WM. H. ZIMMER POWER STATIONINSTRUCTIONS FOR UPDATING YOUR  
DESIGN ASSESSMENT REPORT

Changes to the MARK II DAR are identified by a vertical line in the right margin of the page. To update your copy of the ZPS-1 DAR, remove and destroy the following pages and figures and insert pages and figures as indicated.

AMENDMENT 15  
MAY 1981

MARK II DESIGN ASSESSMENT REPORT

FIGURE 5.2-5

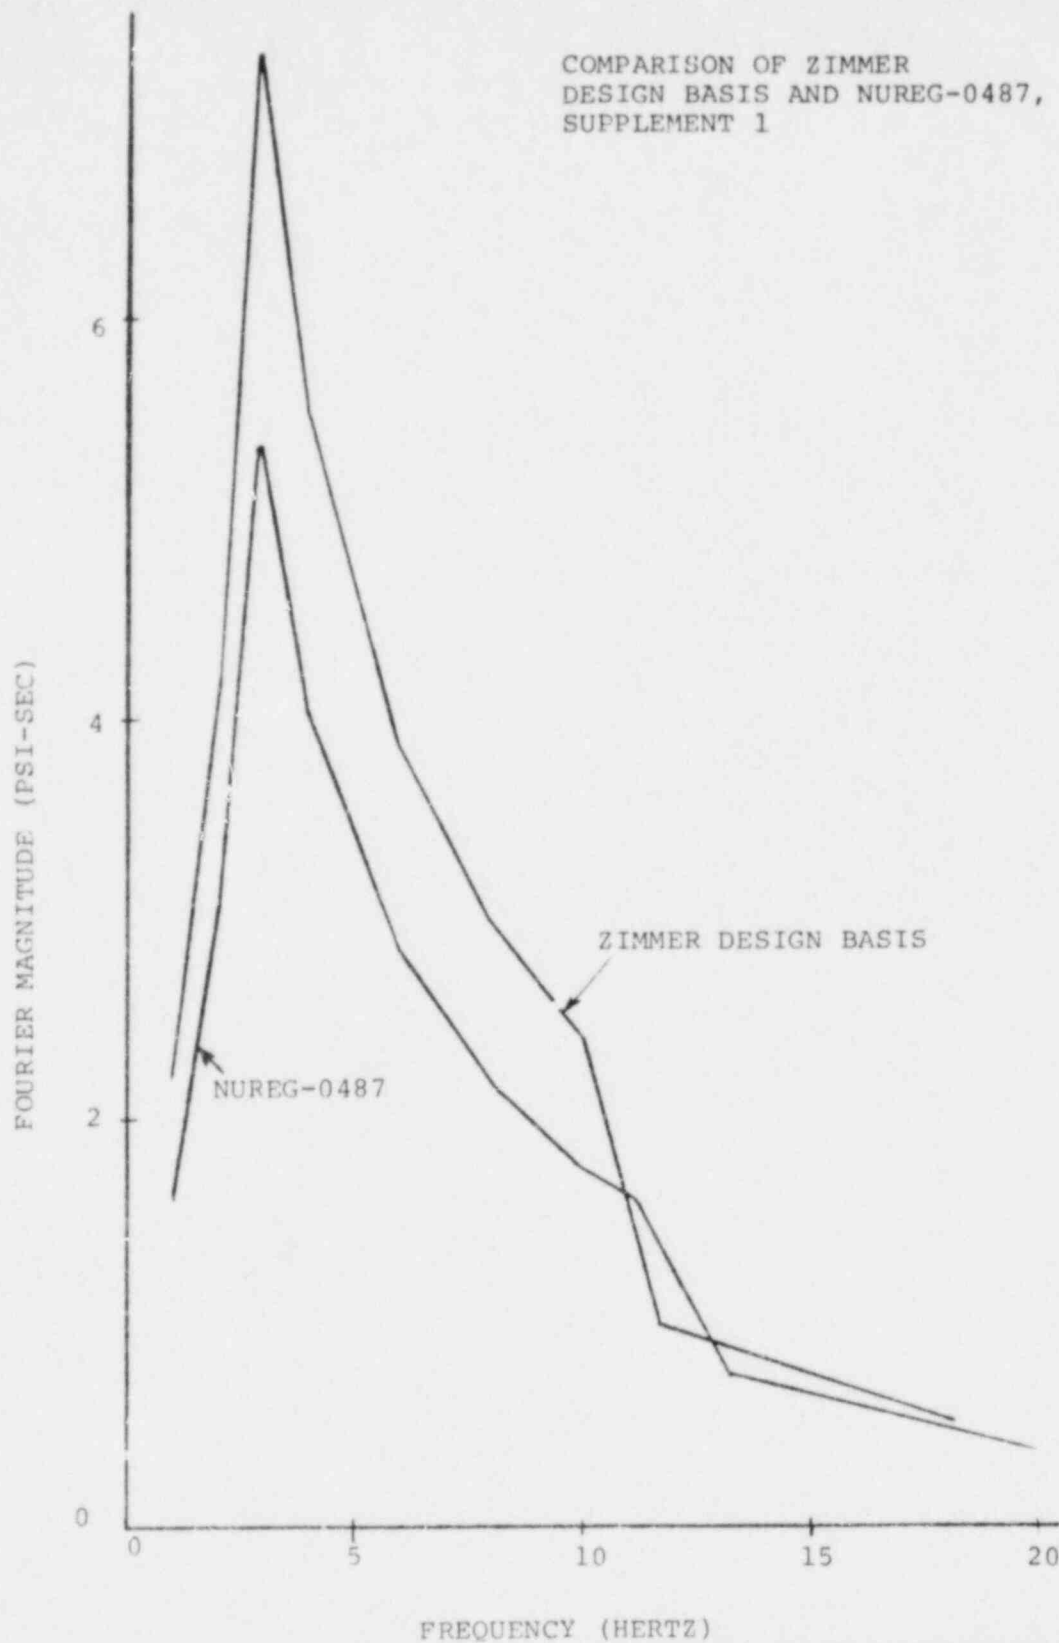
In order to demonstrate the adequacy of the William H. Zimmer Station design-basis frequency range for the all valve discharge case, a comparison was made between it and the frequency range provided in NUREG-0487, Supplement 1 (September 1980). The comparison was accomplished by generating envelopes of the magnitude of the Fourier transforms of the sets of factored design traces produced by the two methods. The Zimmer Station design basis is derived from using a 1.5 amplitude multiplier on the three KWU design traces and sweeping a dominant frequency range of 2.9 to 9.9 hertz. The NRC design basis is derived from using a 1.1 amplitude multiplier on the three KWU design traces and sweeping a dominant frequency range of 3 to 11 hertz. The resulting design envelopes are compared in the attached figure. Note that the Zimmer design-basis is 35% higher than the NRC design basis except in the narrow frequency range of 11 to 13 Hz. In this narrow range, the NRC design basis is, on the average, 8% higher.

- a. The total structural and piping response has contributions from several frequencies. The Zimmer design basis is 35% higher than the NRC design basis except in the 11 to 13 hertz range where it is 8% lower. In our opinion any increase in structural or piping response due to a higher 11 to 13 hertz input will be more than compensated by a lower input (and response) for all other frequencies.
- b. The Zimmer design is based on the simultaneous occurrence of the SSE, LOCA, and the SRV events. As the combined design response has contribution from all three loads, the increase in the SRV response would be more than compensated for by the conservatism Zimmer has used in other portions of its Empirical Design Basis loads. This is illustrated in Subsection 5.3.3.

- c. For design of the Zimmer station, those loads were combined by the absolute sum method. A significant reduction would result from the use of the SRSS (Square Root of the Sum of the Squares) method which has been approved for Mark II use by the NRC.

Based on the above discussion, we conclude that the Zimmer design basis is more conservative than required by NUREG-0487, Supplement 1.
